Value Engineering Study

Final Report

VE Number: 202303

I-75 Widening, MP 20.2 to MP 28.851 Laurel & Whitley Counties

38

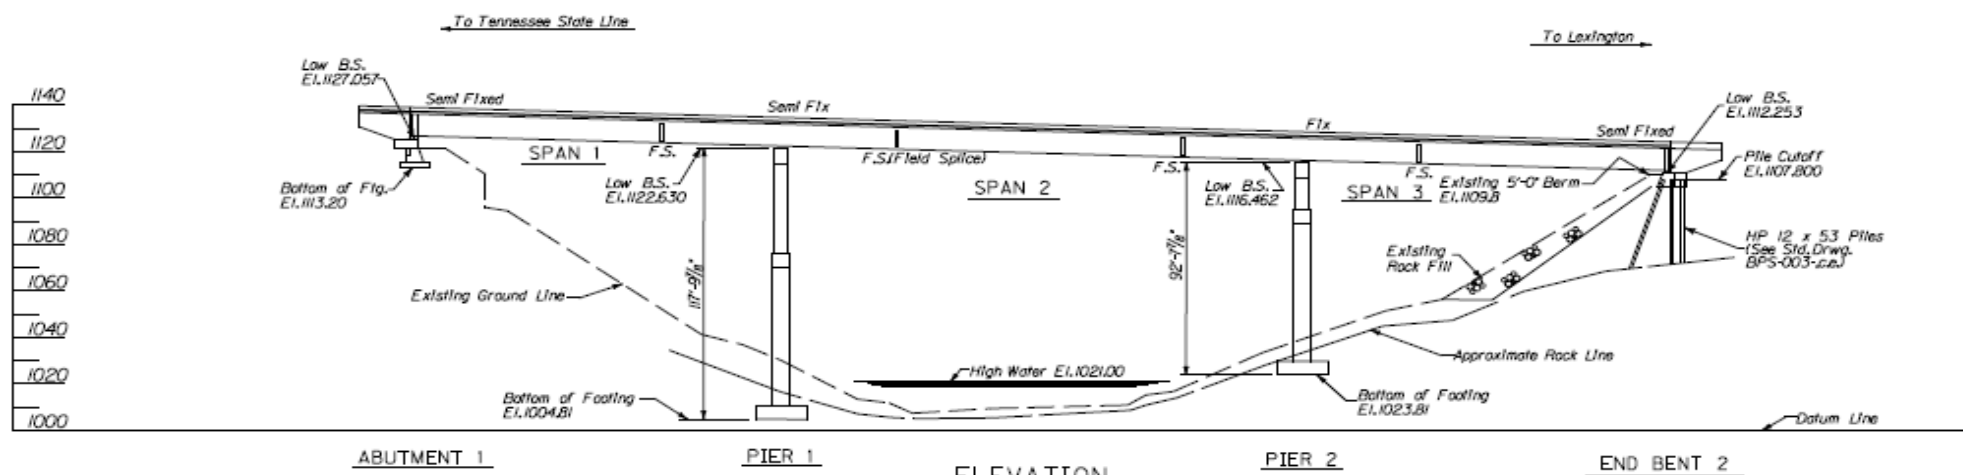
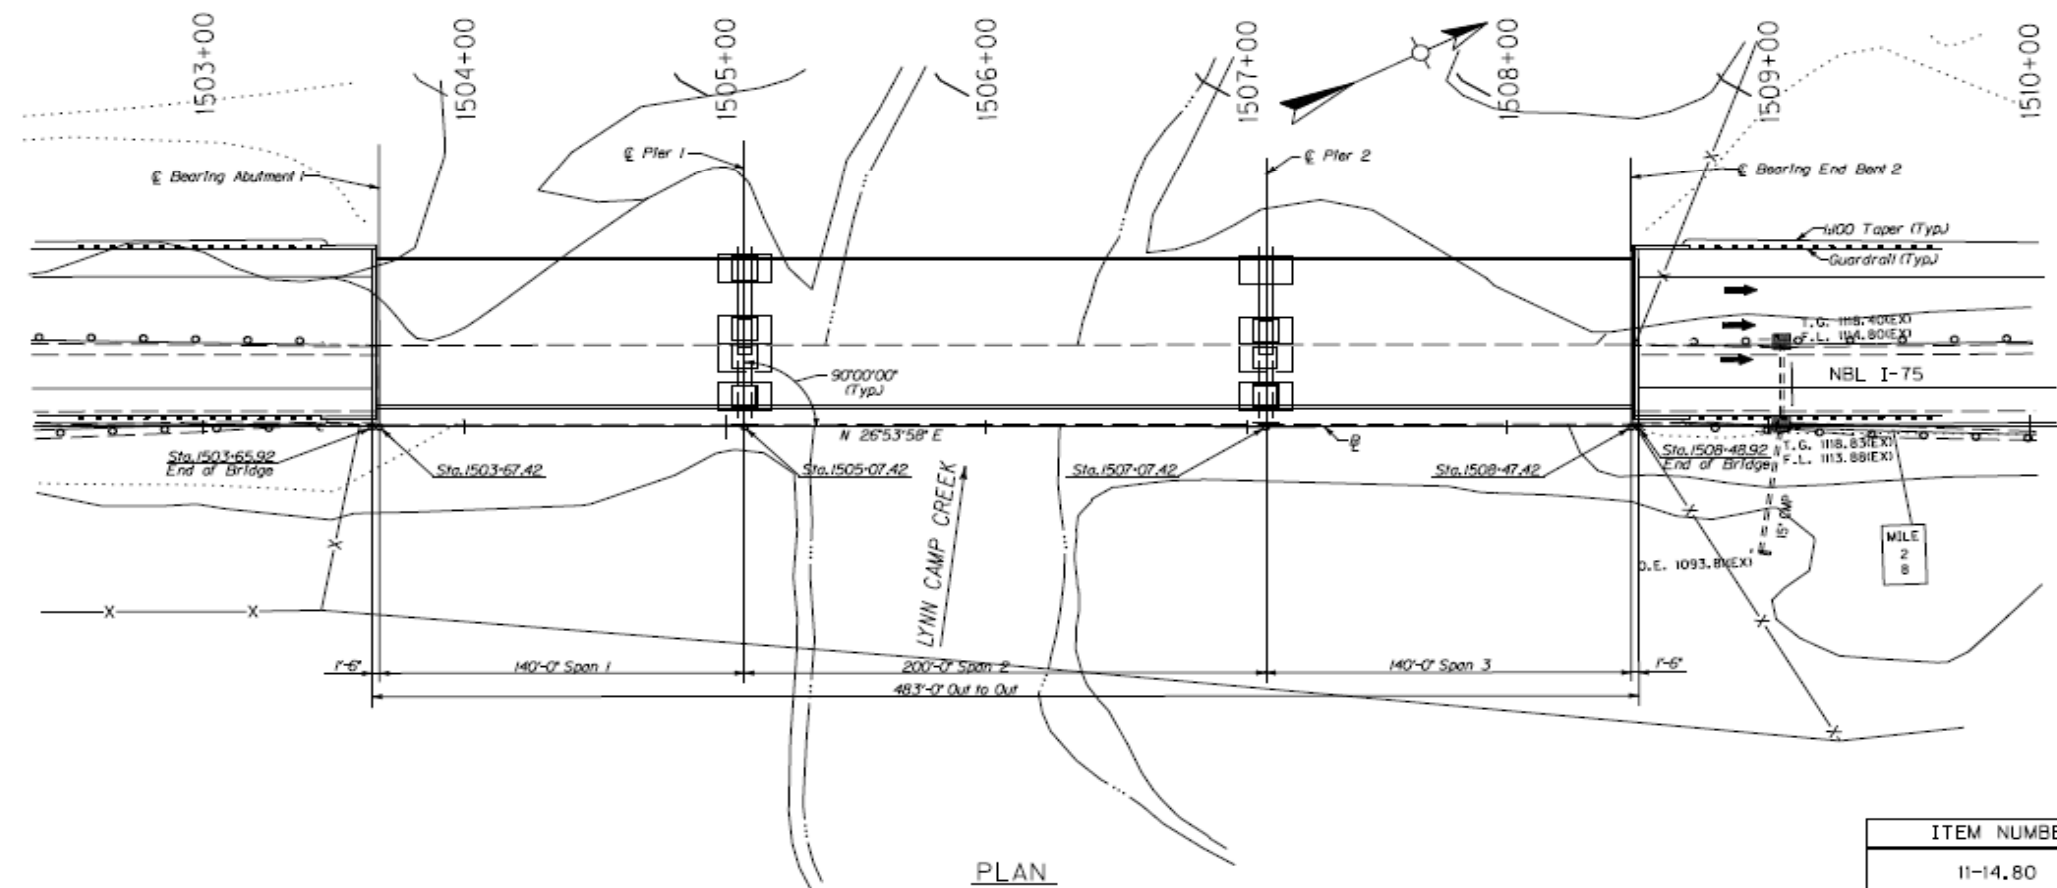
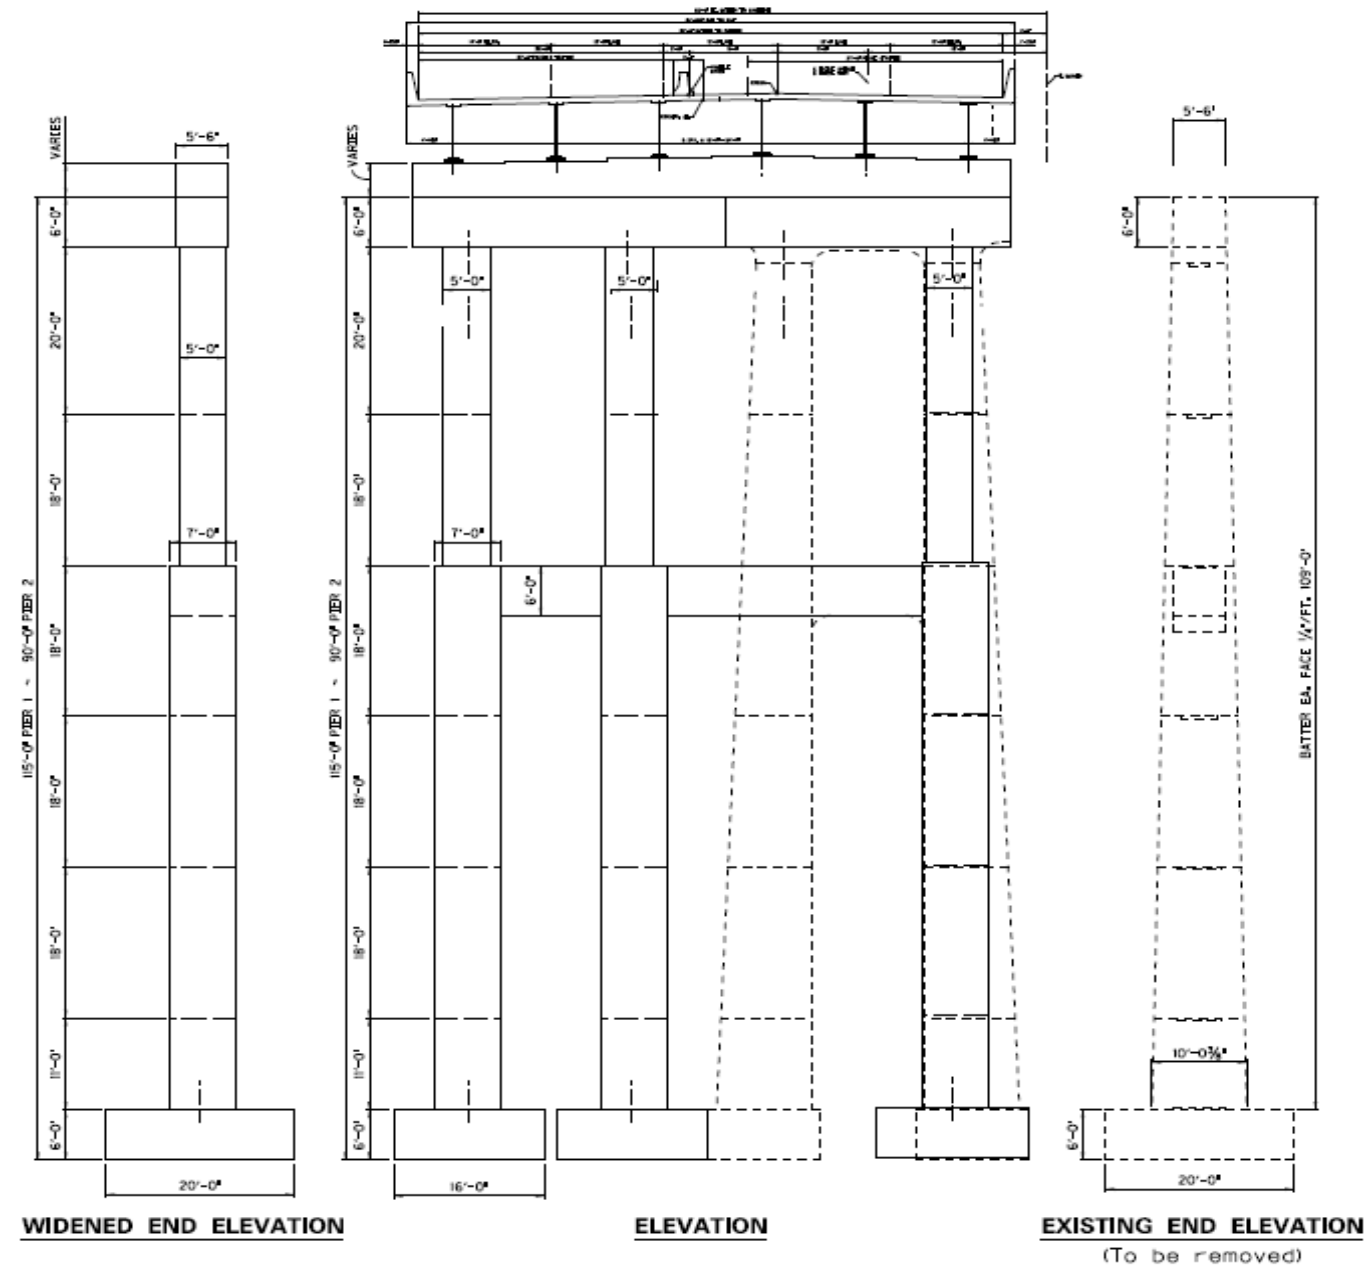
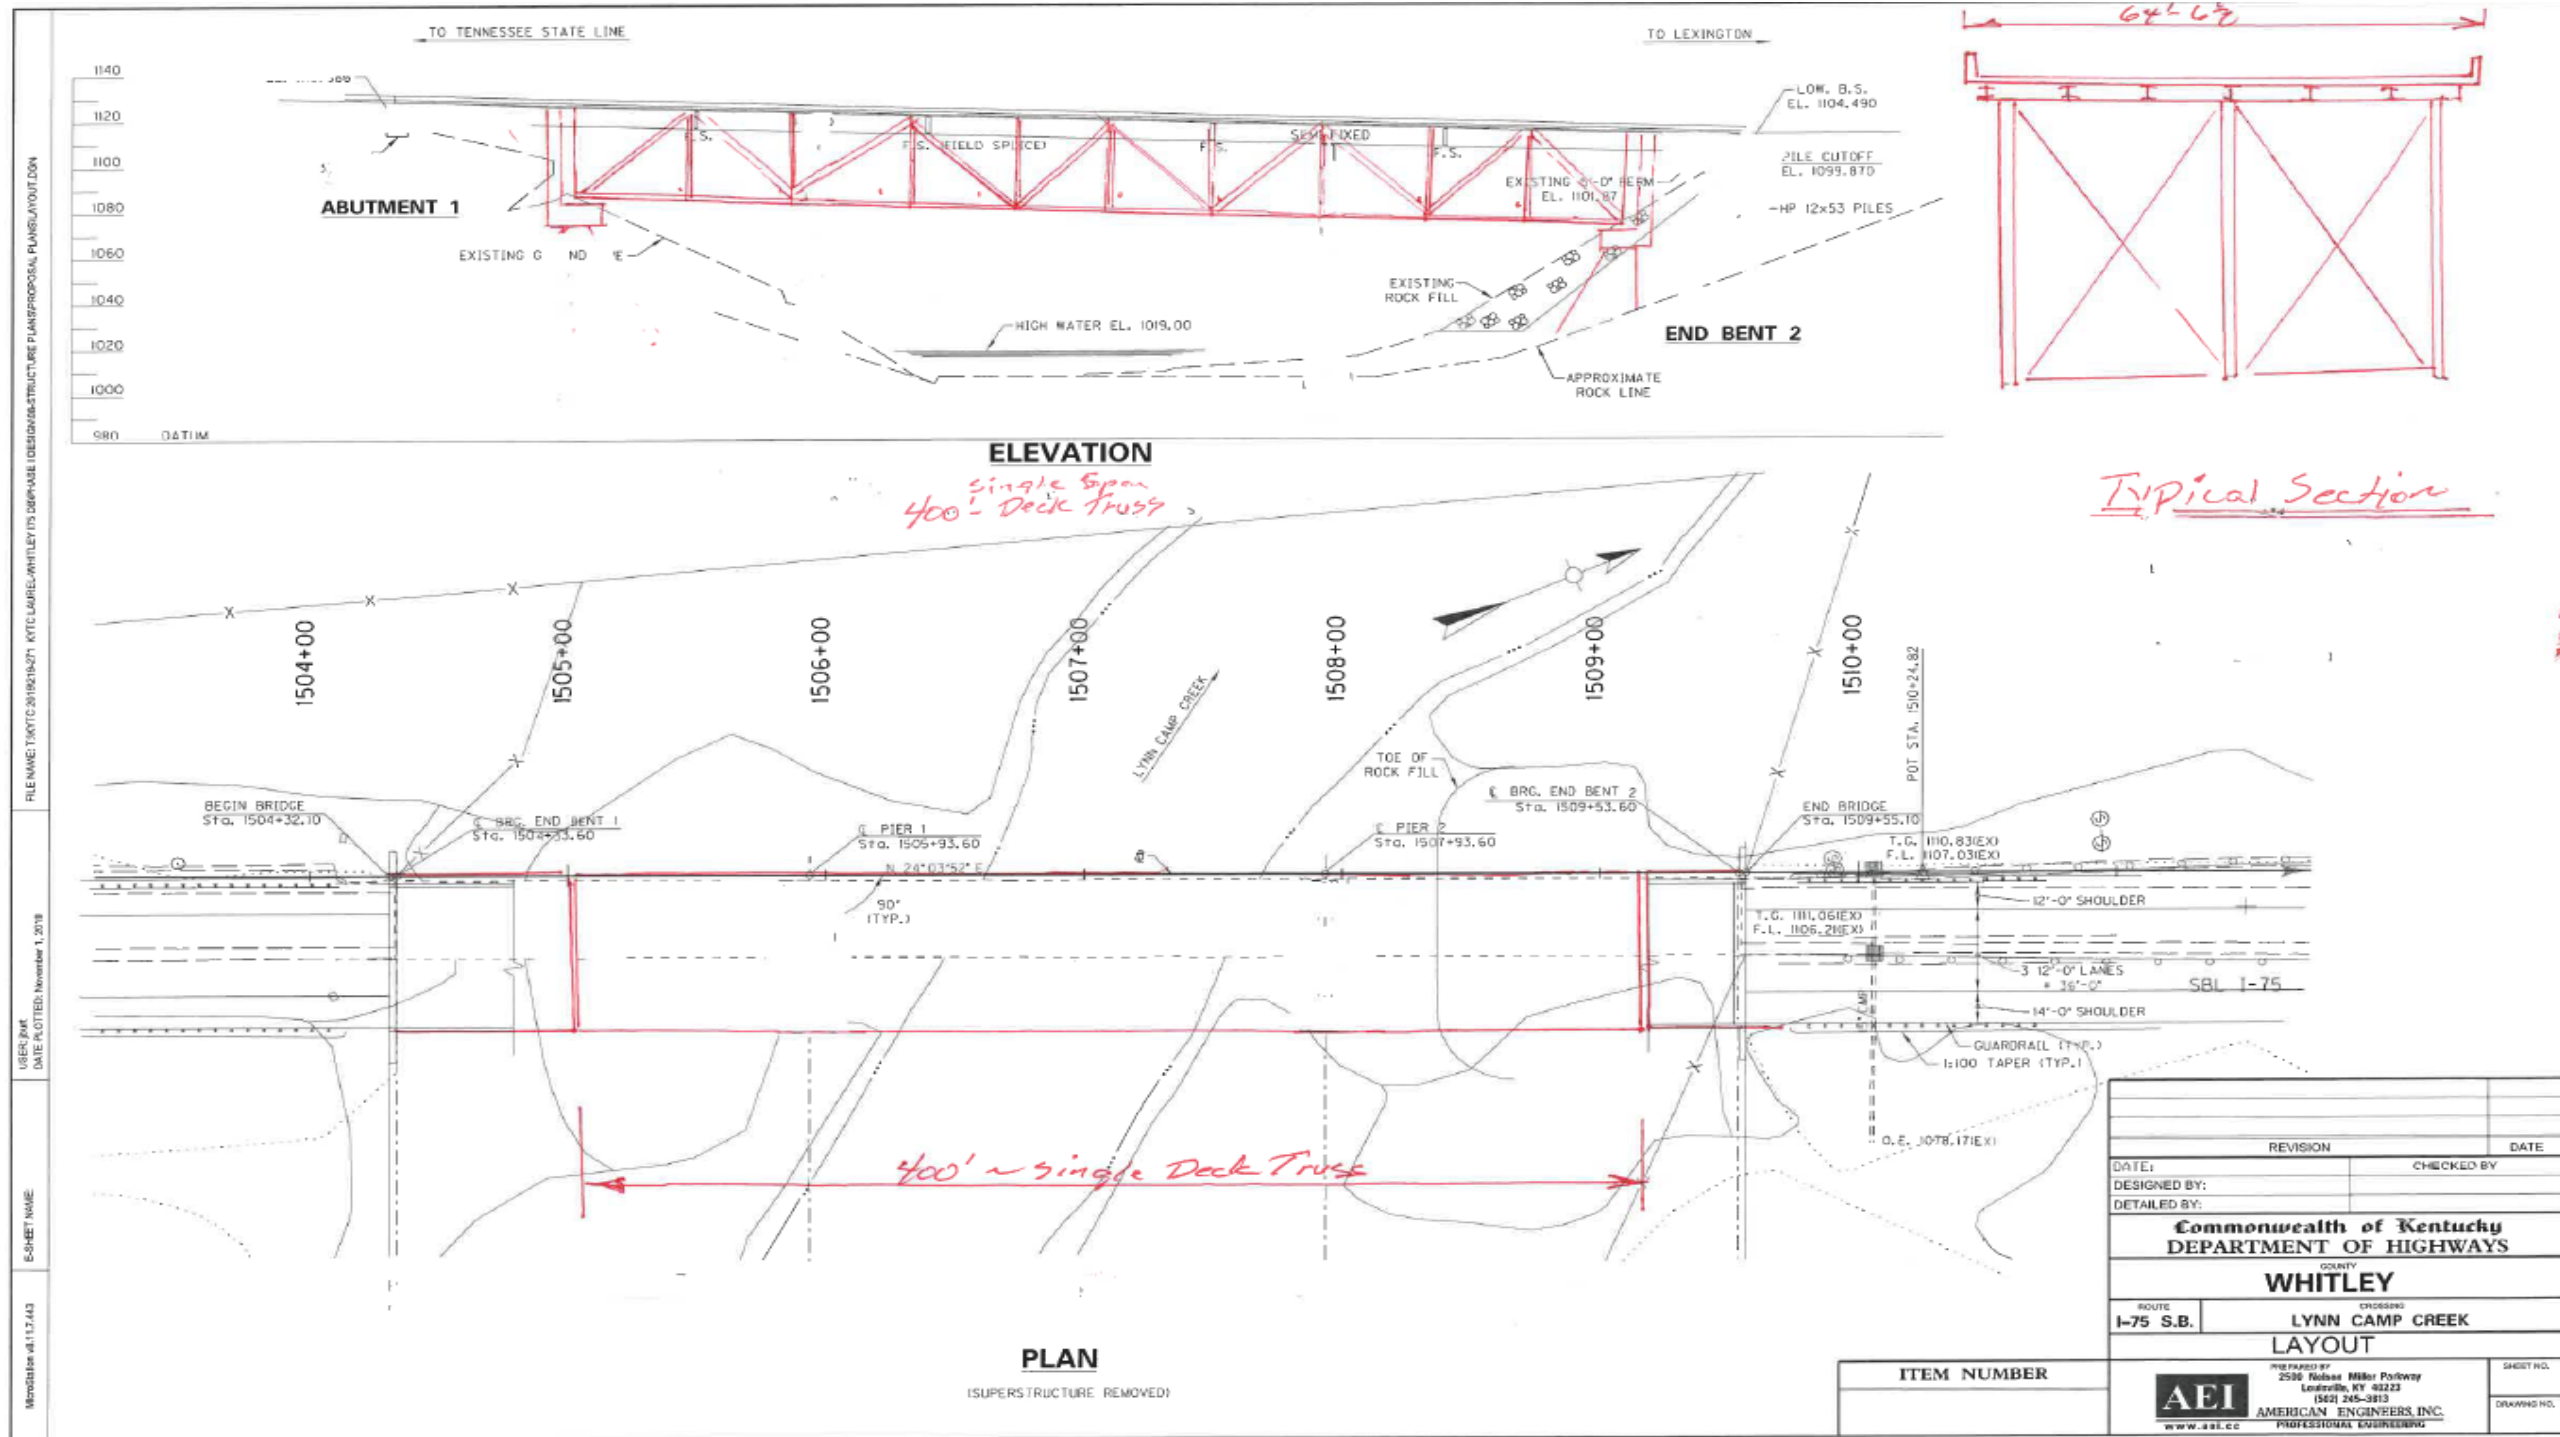
TITLE	Build Lynn Camp Bridge as a single span deck truss with no piers		
ASSOCIATED IDEAS	39: Build Lynn Camp Bridge using deck trusses in lieu of plate girder bridge		
VALUE PROPOSAL SYNOPSIS:			
The option uses a single span deck truss to cross Lynn Camp Creek. The option does not use tall piers that the continuous plate girder bridge			
 Reliability	Maintained	 Functionality	Maintained
 O&M	Maintained	 Schedule Impact	Maintained
			\$ Initial Cost Avoidance (Add)
			(\$1,616,000)
BASELINE CONCEPT:			
A new bridge for NB and SB over Lynn Camp Creek is desired by KYTC. The basic configuration of a new bridge would be a continuous three span (160-200-160) steel Plate Girder bridge with widen new piers in the same location as the existing piers.			
VALUE PROPOSAL DESCRIPTION:			
Construction of tall piers (90'-100') can be avoided by using a deep deck truss span. The natural slope up from Lynn Camp Creek will meet the bottom of the proposed truss such that shallow abutments or End Bents can be utilized.

TITLE	Build Lynn Camp Bridge as a single span deck truss with no piers
DISCUSSION & JUSTIFICATION:	
<p>The information provided by the project team led the value team to conclude that the final design of the Lynn Camp Creek bridge will be a continuous three-span steel plate girder bridge. The baseline structure will replace the piers in their current location. However, construction of the new piers poses a constructability concern.</p> <p>The value team proposes to place a single span deck truss with no piers. This would minimize the need for equipment to be down near the creek such as concrete pumps and concrete trucks.</p> <p>Access to the creek will still be needed for temporary shoring supports, crane access, etc.</p> <p>By eliminating the pier construction, the phasing duration for the bridge construction is greatly reduced, however, the complexity of the truss construction would mean that the project time is ultimately expected to remain the same. It is assumed that the Lynn Camp Creek structure will be on the critical path of the project.</p>
